AIA Document G701® – 2017

Change Order

PROJECT: *(Name and address)*
Mansfield ISD 2024 Bond Program A3
Legacy High School Baseball/Softball Turf
& Batting Cages
1263 North Main Street
Mansfield, TX 76063

Final project reconciliation deductive change order.

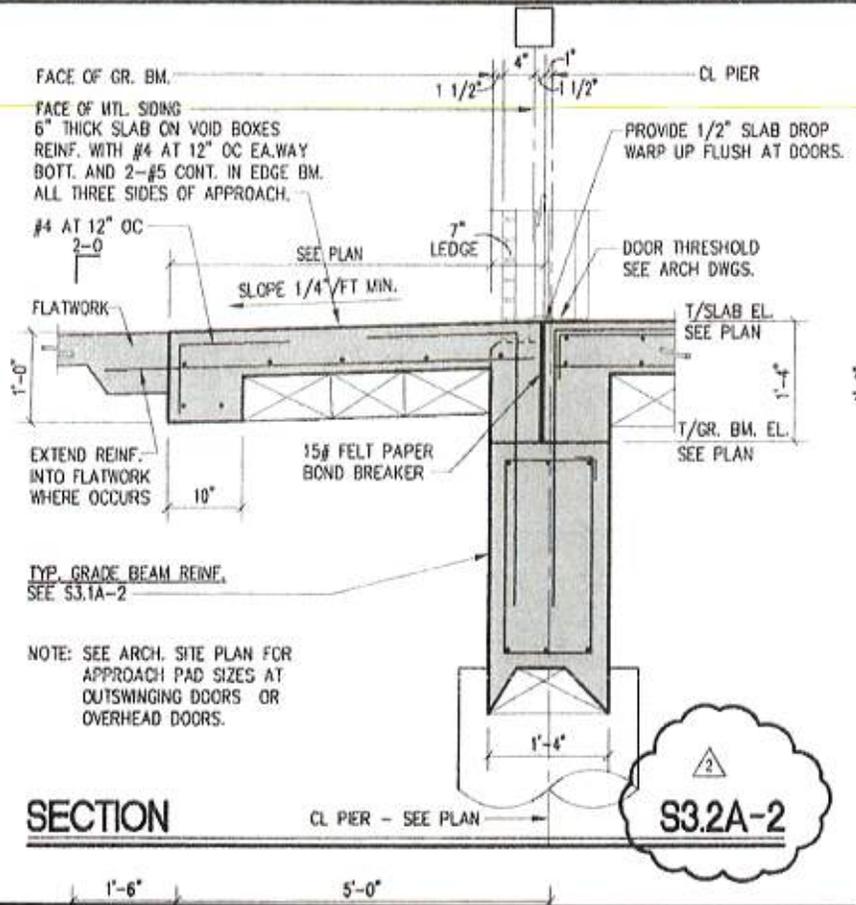
Structural Stoop per detail provided by CCC.
Material: \$608 (additional concrete, rebar, dowels, void form, and expansion board)
Labor: \$892 (excavation, forming, and rebar labor)

- RFI - 31 Batting Cage Fencing Add.png

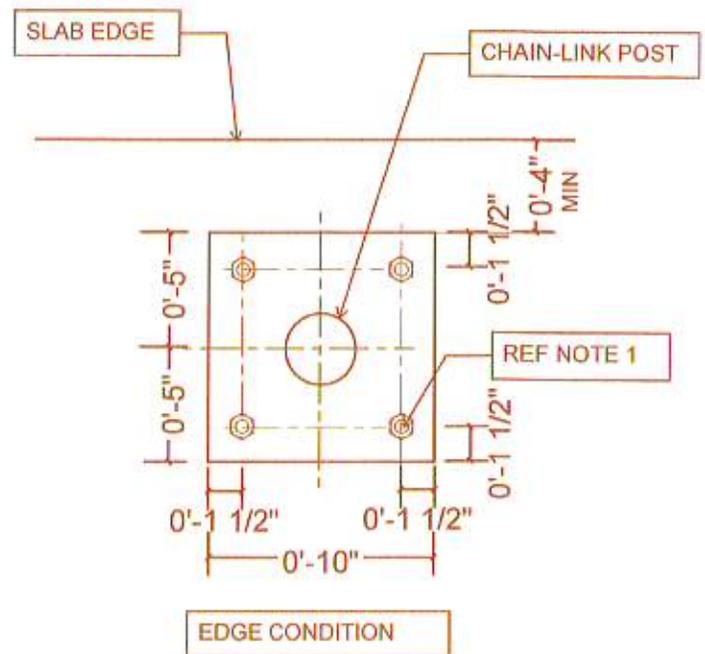
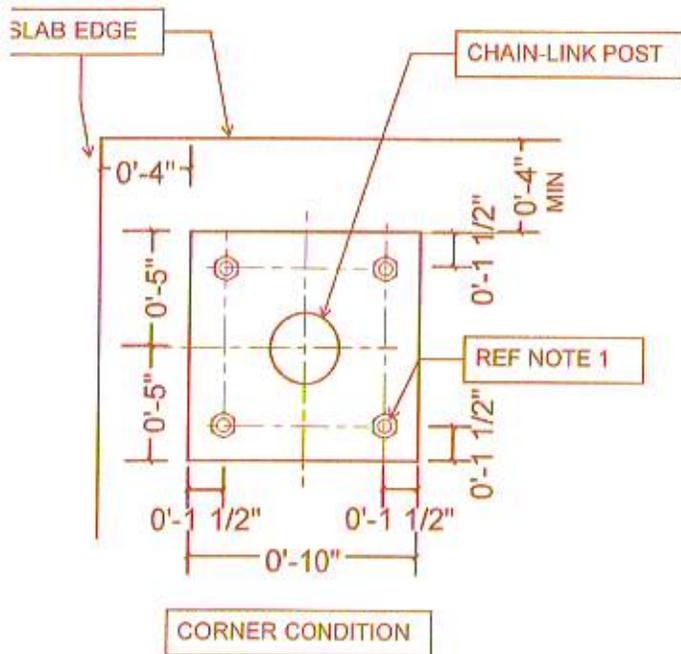
6ft tall black vinyl chain-link fencing mounted between PEMB columns. Provide mounting detail to review structural and MISD.

1 - PROVIDE (4) 5/8" DIA POST-INSTALLED HAS RODS ADHESIVE ANCHORS WITH MINIMUM 6" EFFECTIVE EMBEDMENT DEPTH. ADHESIVE SHALL BE HILTI HIT-HY 200-R V3 OR EQUAL.

2 - PROVIDE 3/4" THICK BASE PLATE.

4- PRIOR TO FABRICATION, CONTRACTOR SHALL VERIFY THE SIZE AND LOCATION OF EXISTING METAL BUILDING COLUMNS AND COLUMN BASE PLATES. CONTRACTOR SHALL ADJUST THE LOCATION OF NEW FENCE POST BASE PLATES AS REQUIRED TO AVOID CONFLICTS WITH EXISTING COLUMNS AND COLUMN BASE PLATES.

6- PROVIDE (3) POSTS MINIMUM BETWEEN EACH PAIR OF MAIN METAL BUILDING FRAME COLUMNS. FENCE SHALL TERMINATE BETWEEN MAIN FRAME COLUMNS AS SHOWN.

7- FENCE SHALL BE CONTINUOUS ALONG THE WIND COLUMN SIDE AND SHALL BE INSTALLED BEHIND THE COLUMNS. PROVIDE BASE PLATES WITH MINIMUM 4" CLEAR DISTANCE FROM EDGE OF EXISTING CONCRETE.
